SUNDRY NOTICES AND REPORTS ON WELLS
Do not use this form for proposals to drill or to re-enter an abandoned well. Use form 3160-3 (APD) for such proposals.

| 3b. Phone No. (include area code) Ph: 405-935-4275 | | 8. Well Name and No. PLU ROSS RANCH 20 FEDERAL 1H |

CHESAPEAKE, RESPECTFULLY, REQUESTS PERMISSION TO MAKE THE FOLLOWING CHANGES:

REVISED DRILLING PROGRAM 1/7/2011

BLOWOUT PREVENTOR SCHEMATIC

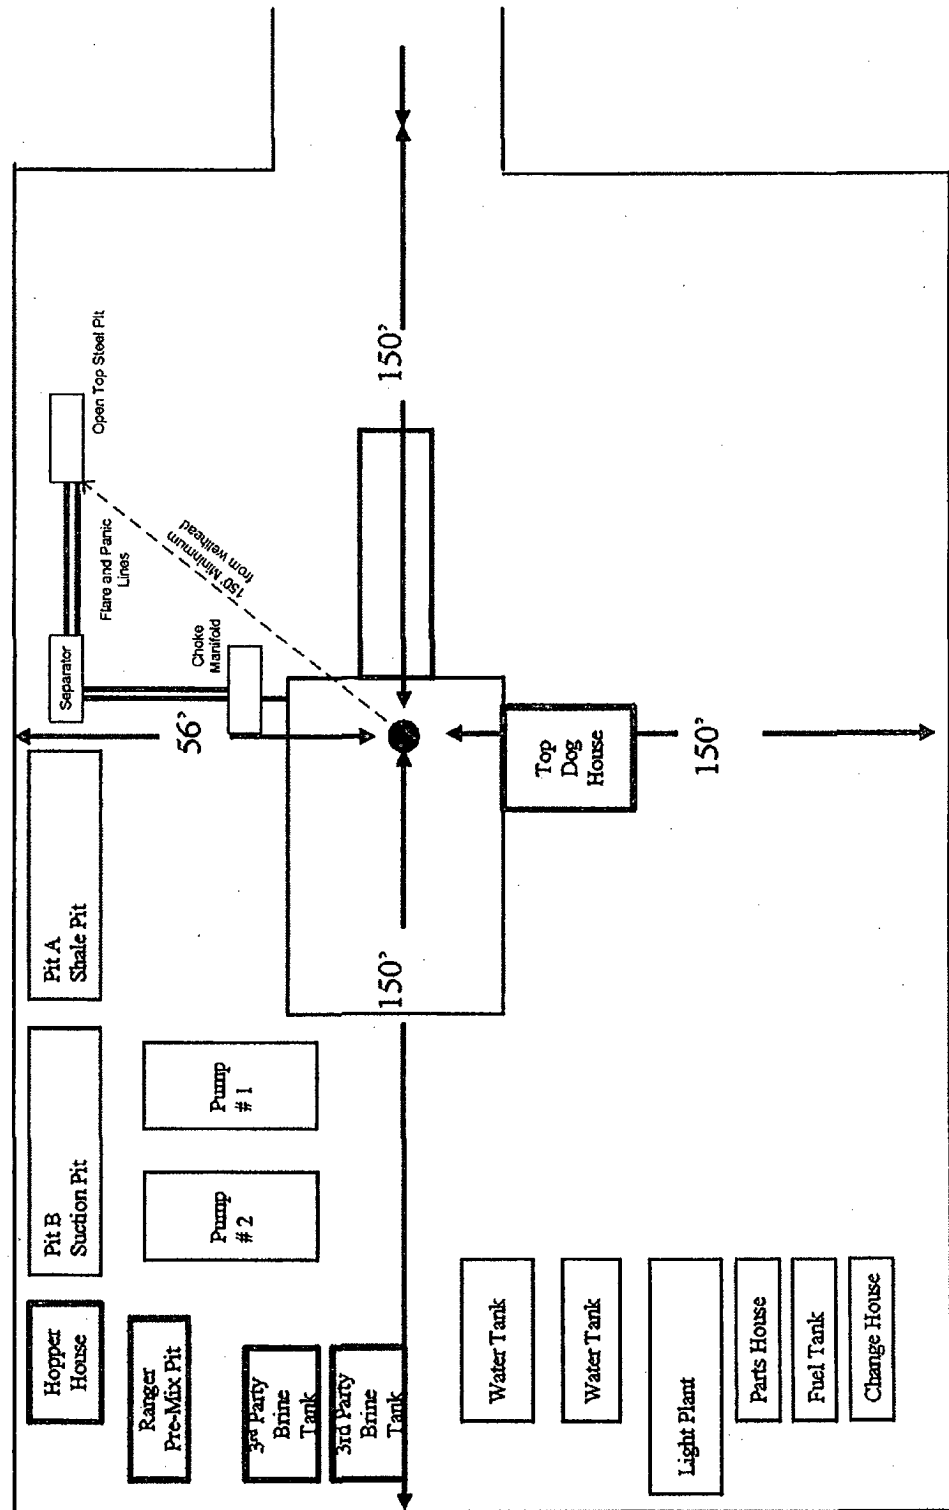
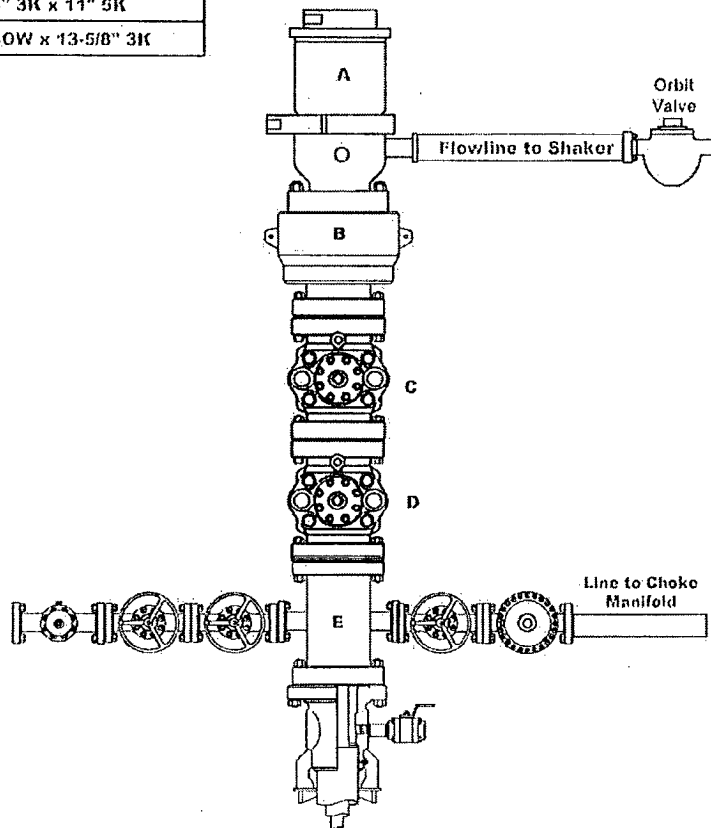
Will have a 5000 psi rig stack (see proposed schematic) for drill out below surface casing, but this system will be tested to 3000 psi working pressure and 3000 psi working pressure for the annular preventer; therefore, no shoe tests will be conducted.

Well Name: PLU Ross Ranch 20 Federal 1H
County, State: Eddy County, NM
Surface Location: 100' FNL 400' FWL, Section 20, Township 25S, Range 30E
BH Location: 330' FSL 400' FWL, Section 20, Township 25S, Range 30E

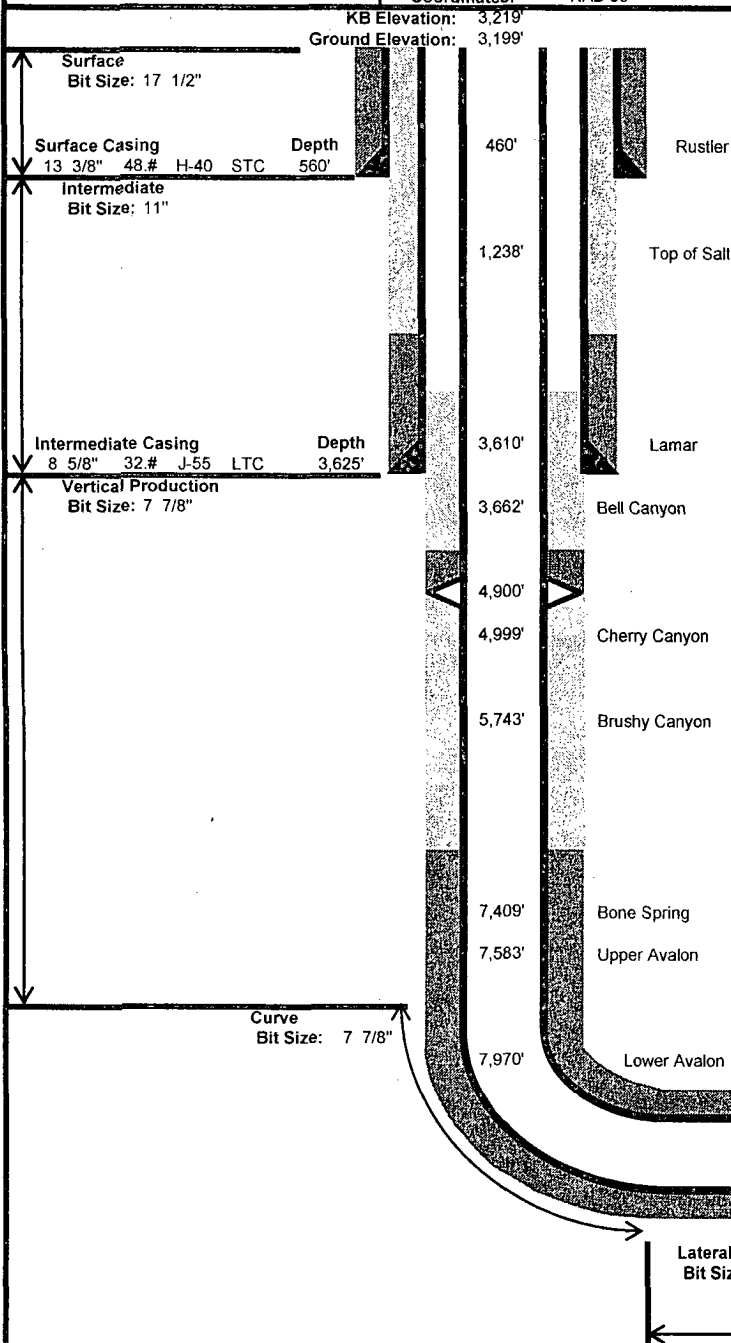
RIG CHANGE TO PATTERSON 62
CHANGE IN DIRECTIONAL DRLG PLAN
CHANGE IN FORMATION TOPS
CHANGE IN CASING SETTING DEPTHS

ATTACHED IS THE RIG PLAT, BOP/CHOKE SCHEMATICS FOR PATTERSON 62, REVISED DRILLING PROGRAM (CHANGES HIGHLIGHTED), REVISED DIRECTIONAL DRLG PLAN AND REVISED WELLBORE SCHEMATIC.

1. **The 13-3/8 inch surface casing shall be set at approximately 800 feet (a minimum of 25 feet into the Rustler Anhydrite and above the salt) and cemented to the surface. If the salt is encountered at a shallower depth, the casing must be set 25 feet above the top of the salt. Fresh water mud to be used to setting depth.**
 - a. **If cement does not circulate to the surface, the appropriate BLM office shall be notified and a temperature survey utilizing an electronic type temperature survey with surface log readout will be used or a cement bond log shall be run to verify the top of the cement. Temperature survey will be run a minimum of six hours after pumping cement and ideally between 8-10 hours after completing the cement job.**
 - b. **Wait on cement (WOC) time for a primary cement job is to include the lead cement slurry.**
